то	Zac Lovell	DATE	21/10/2025
FROM	Josh Farner	TIME	
PROJECT	New Tasmanian Youth Justice Facility	PROJECT Nº	24.0447
SUBJECT	Response to Council RAI	REF Nº	EA-C02

A Request for Additional Information (RFI) was received from Southern Midlands Council for the proposed Tasmanian Youth Justice Facility (DA2500106) on 30 September 2025.

The additional information concerning to the site Civil design has been provided in Civil Engineering Drawings and a revised Concept Services Report, both dated 21 October 2025. This Engineers Advice provides a summary of the RFI information provided in these documents, and provides further detail where required. It should be noted that the design drawings are for the purpose of concept design for development approval. Further engineering design will be carried out during the detailed design phase to produce the final design and documentation for construction.

Appendix A – 1% AEP Stormwater Overland Flow Mapping

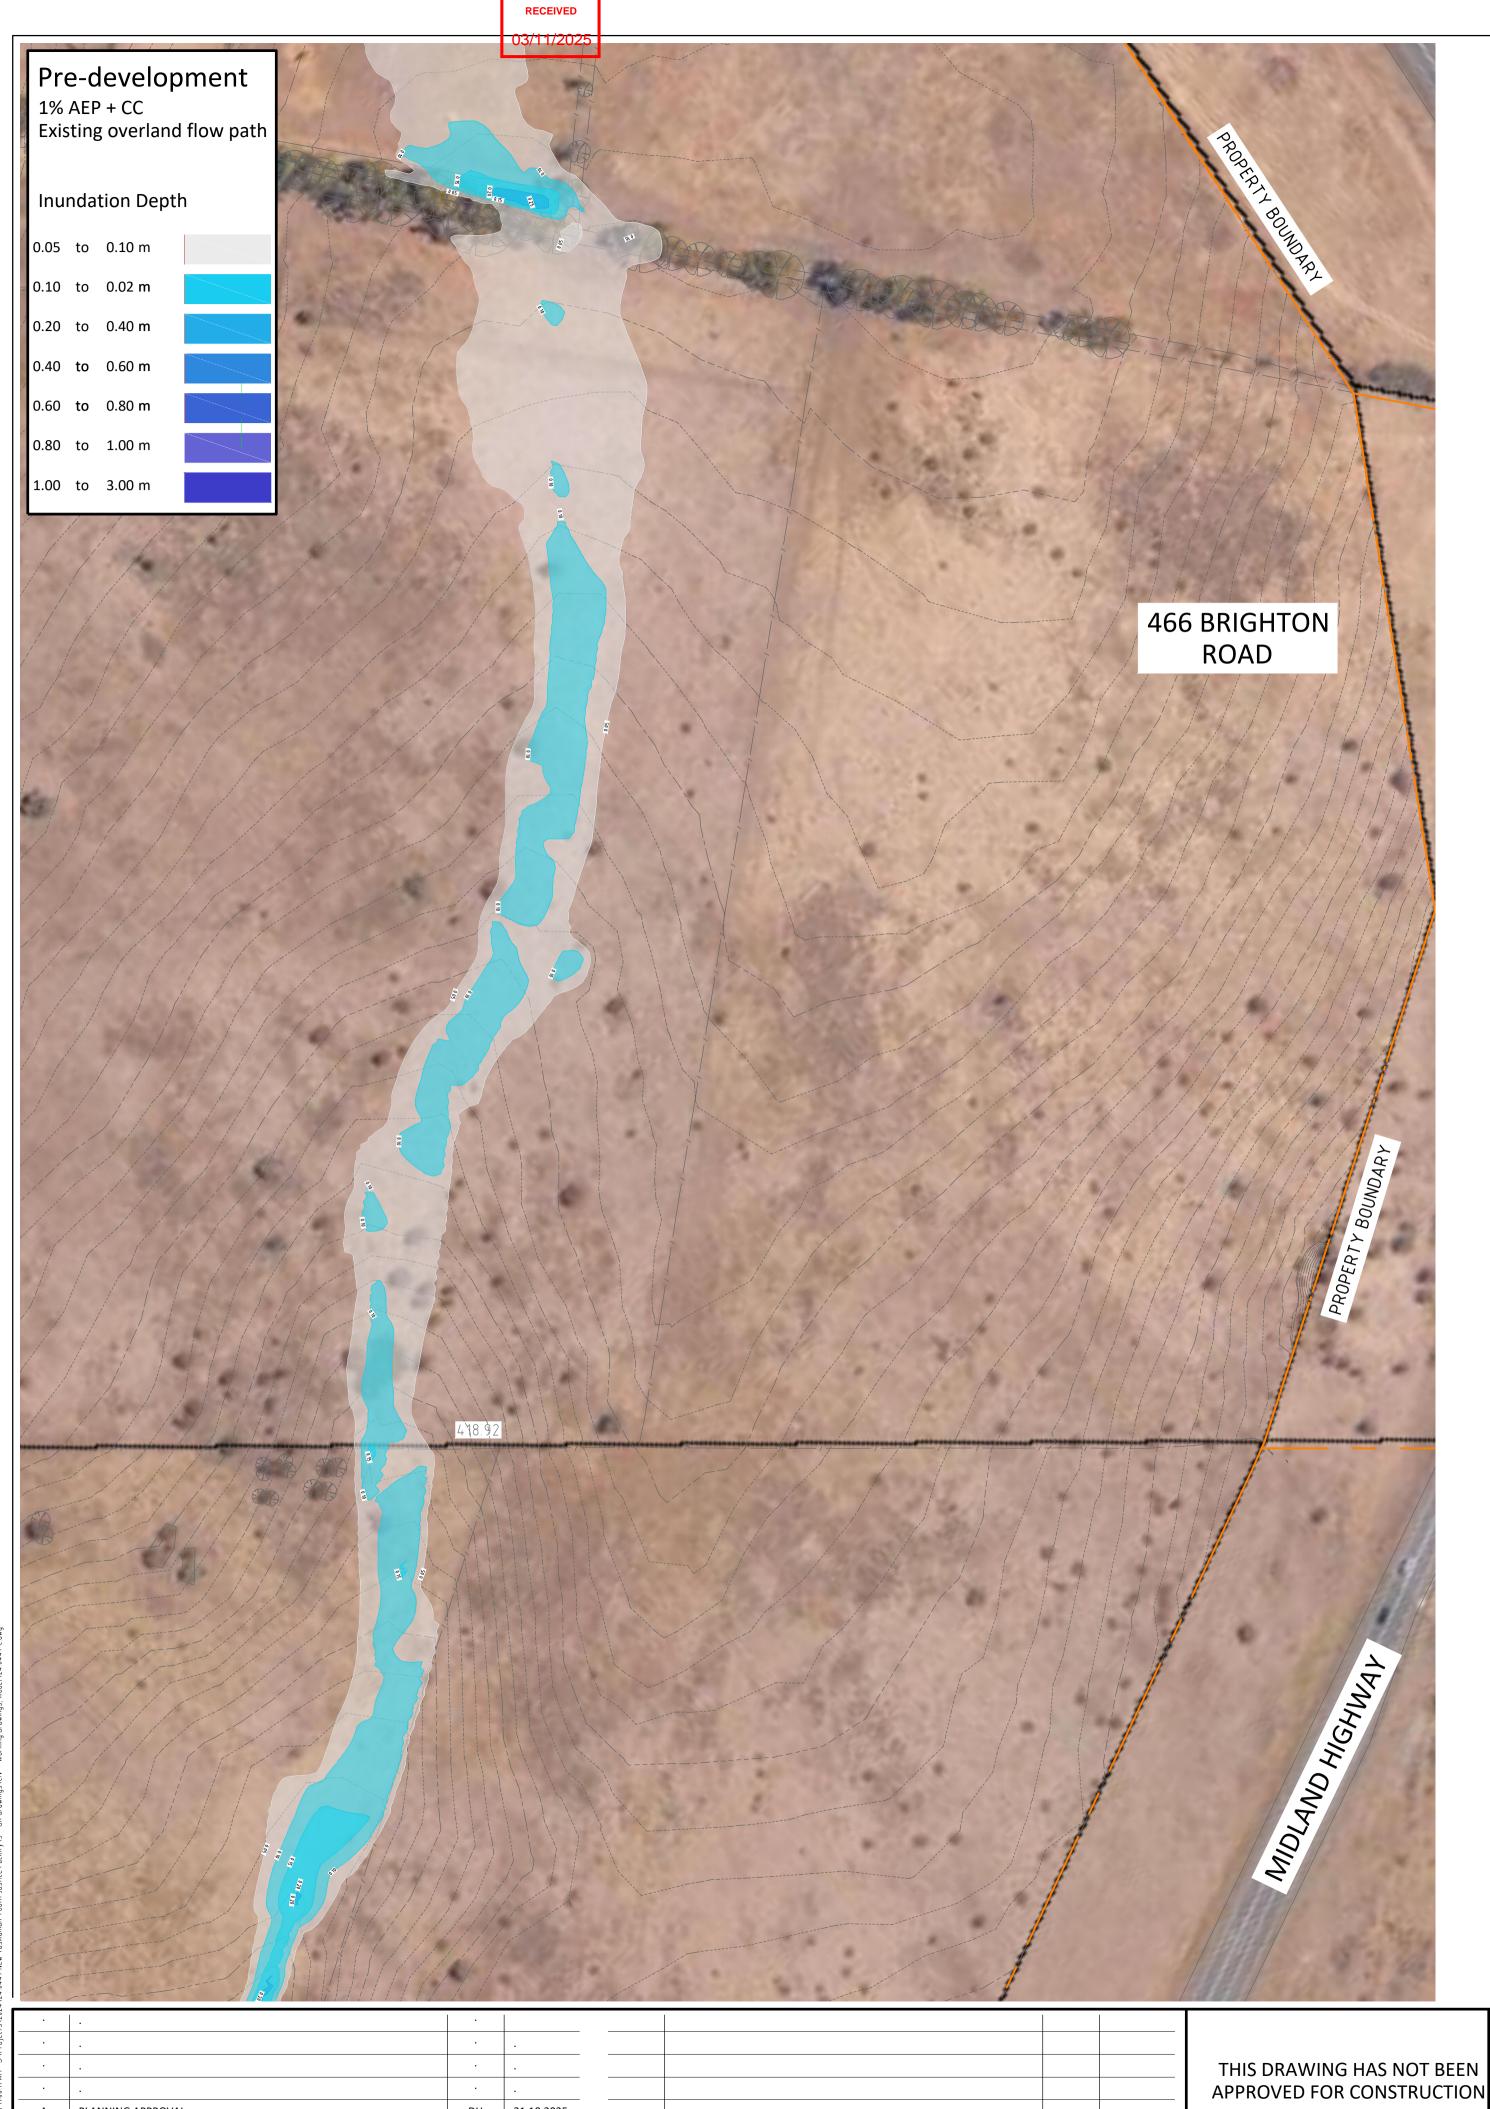
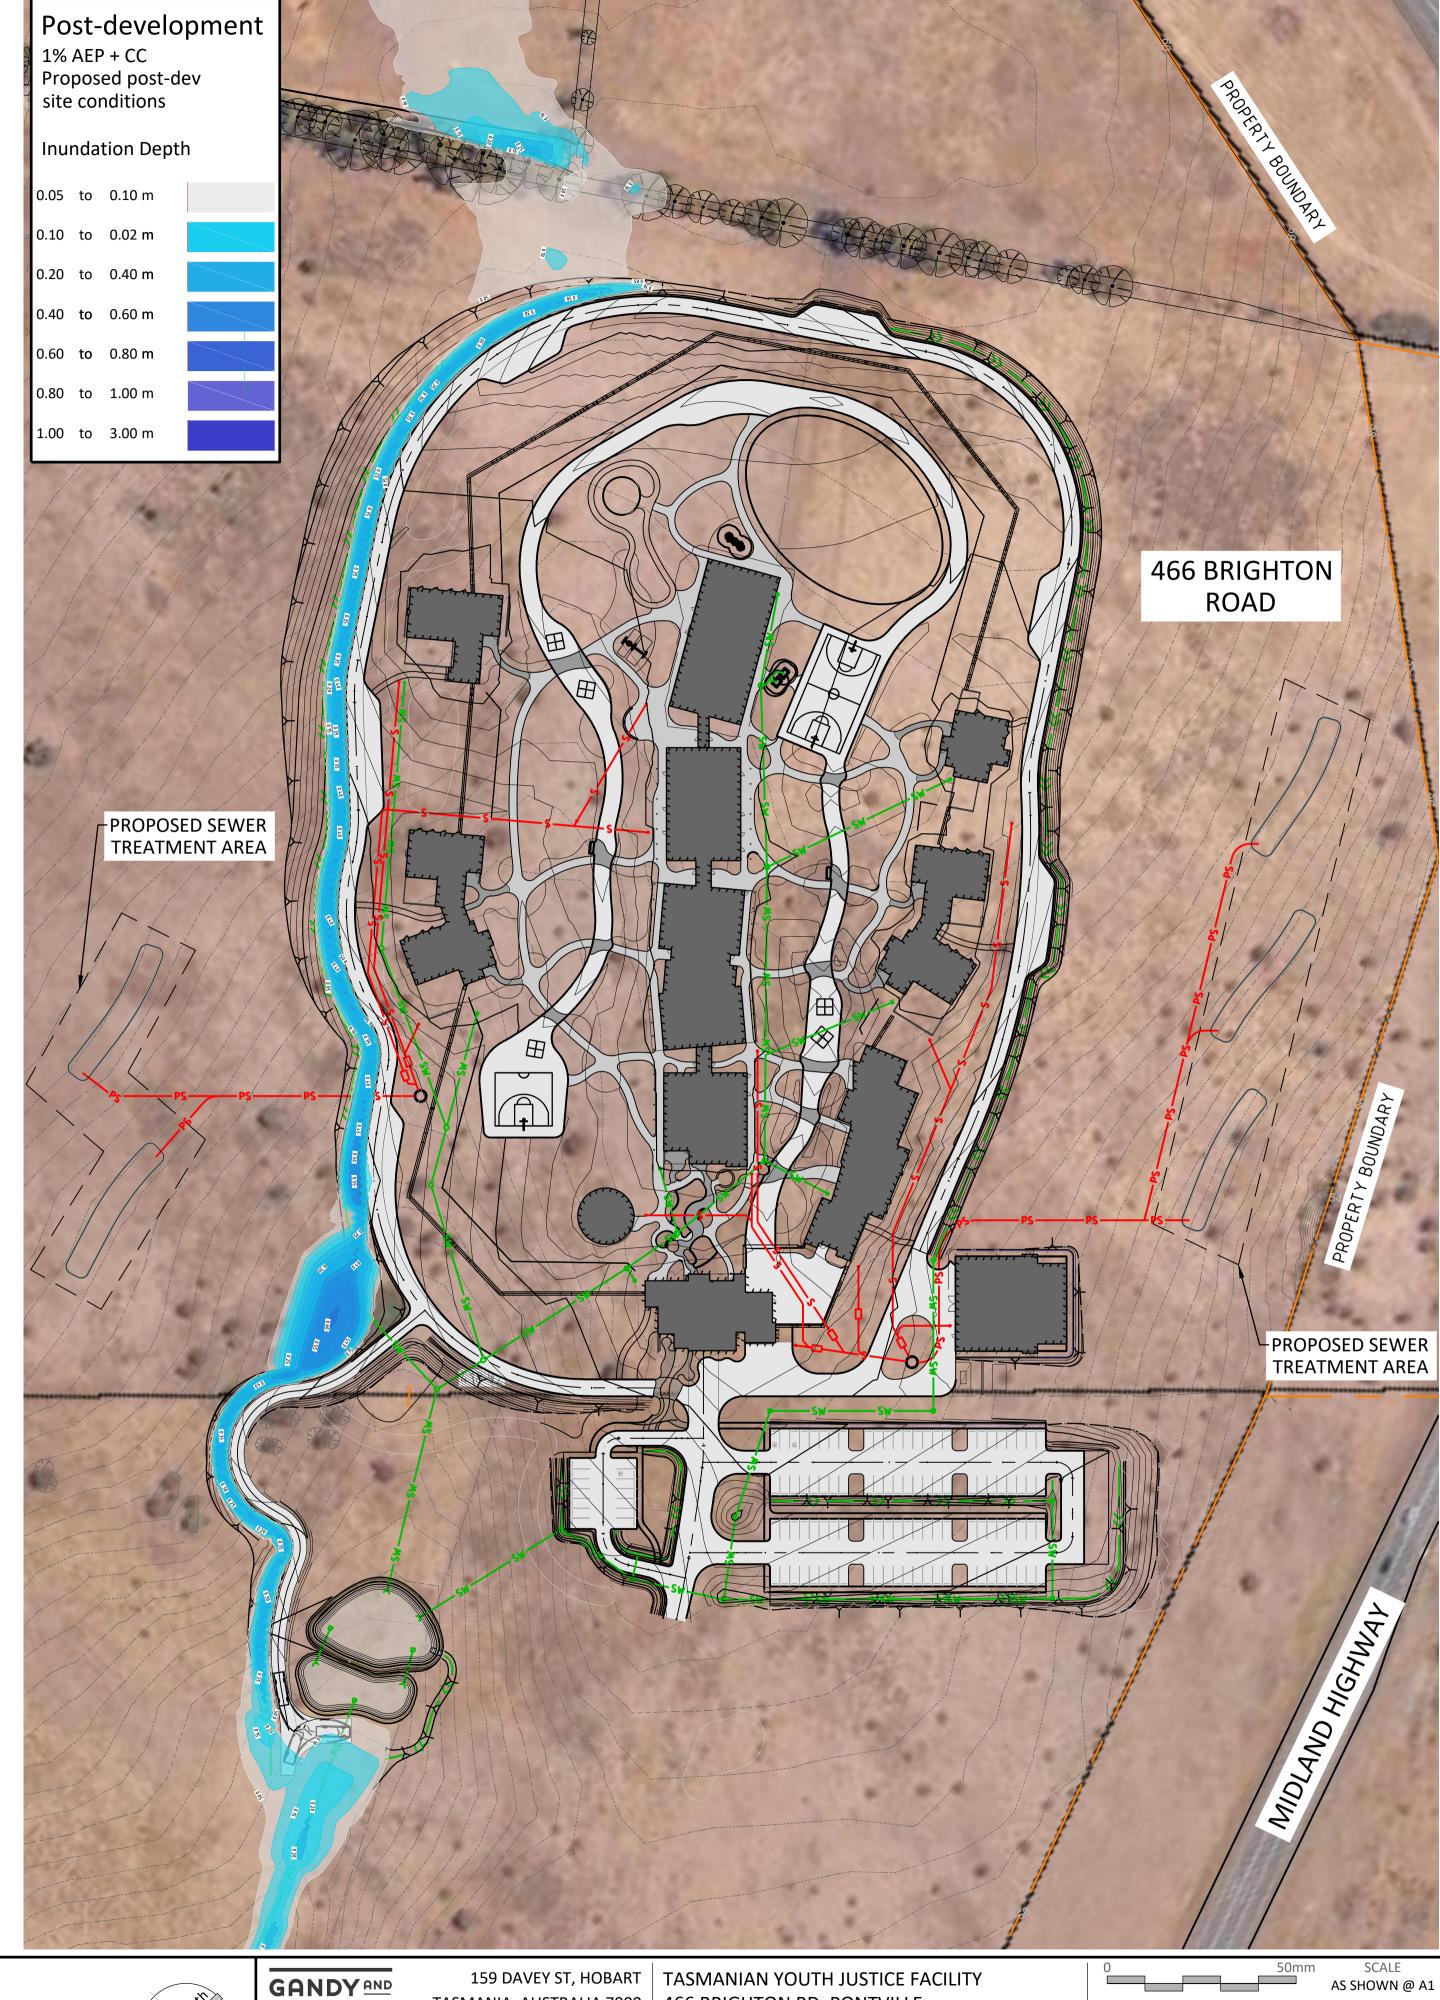
As the site cannot be connected to the Taswater sewer network and is identified within the SES 1% + CC shows H1 hazard level overland flow, please provide a Wastewater Assessment and Design Report prepared by a suitably qualified person to demonstrate that wastewater can be effectively be treated on the site.

The SES 1% + CC shows H1 hazard level overland flow on the property, therefore the land is subject to risk from flood or has the potential to cause increased risk from flood. Council requests that a Flood Hazard Report be prepared by a suitably qualified person.

Also, please provide a Stormwater Management Plan prepare by a suitably qualified person that demonstrates the pre and post overland flow paths.

Refer to the updated Concept Services Report Appendix A for post-development overland flow mapping. The proposed sewer treatment areas are located outside of the post-development 1% AEP overland flow extents.

Refer to Section 2.1 and Appendix A of the updated Concept Services Report for an assessment of overland flow across the site, including pre- and post-development flow mapping for the 1% AEP + CC rainfall event. A revised flow path is proposed to redirect all overland flow around the site perimeter, ensuring an acceptable risk of inundation for the new buildings and users of the facility.

LONGITUDINAL SECTION: ROAD 01
SCALE HOR 1:500 VER 1:100

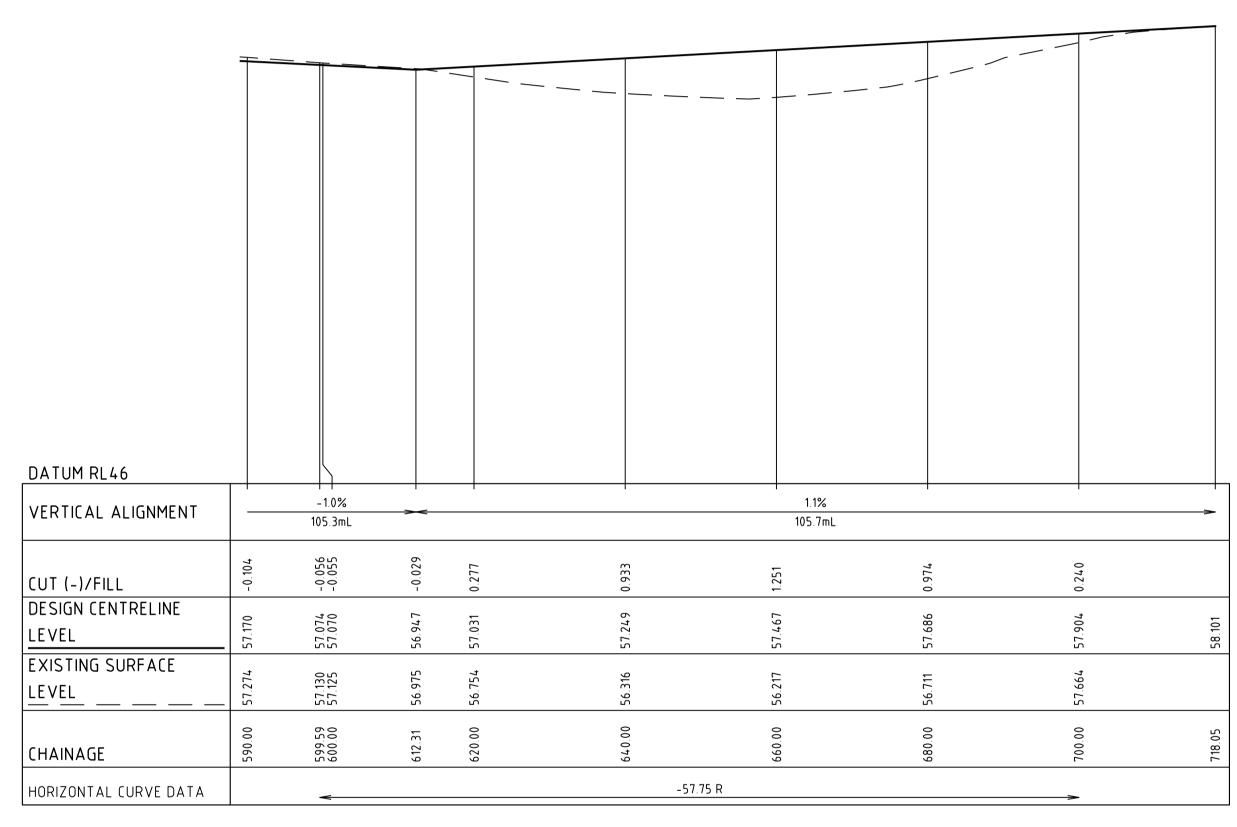
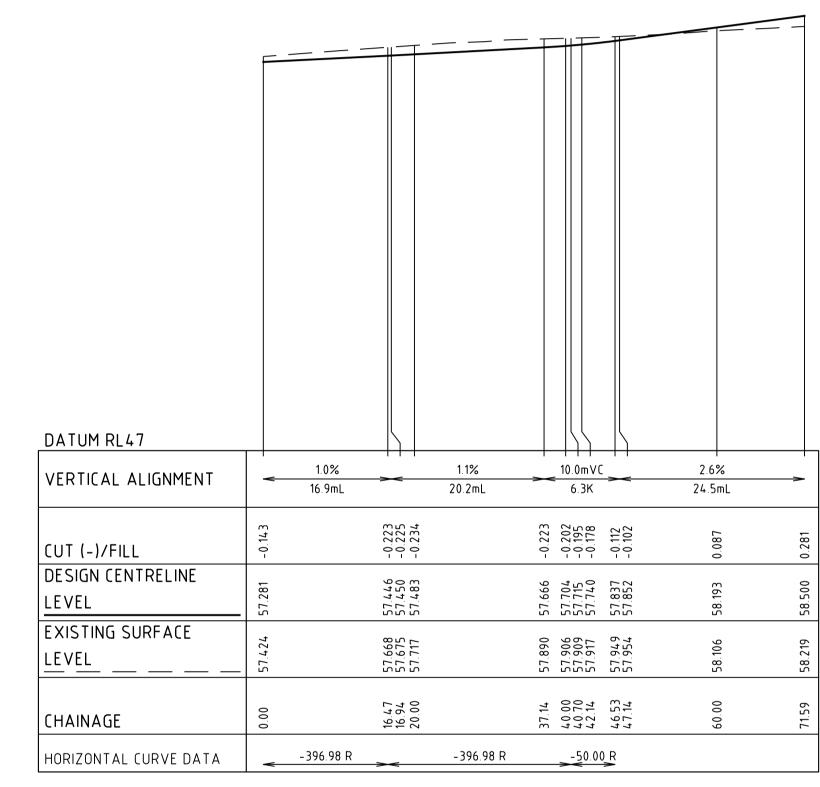
More detail is required to demonstrate how drainage is conveyed from car parking, hardstand, and driveway access areas to onsite detention basin. Details should include car park, hardstand and driveway grades (long sections and cross sections) and typical details of stormwater conveyance system and grades.

More detail is required to demonstrate that car park and access gradients are in accordance with Australian Standard AS 2890 - Parking facilities, Parts 1- 6. Provide cross sections and long sections of car park, hardstand and driveway access and show grades and levels of car parking and hardstand areas required for vehicle manoeuvring.

Refer updated Civil Engineering drawings for concept design finished surface contours, car park and roadway longitudinal sections, stormwater plans and longitudinal sections, and typical road and car park cross sections.
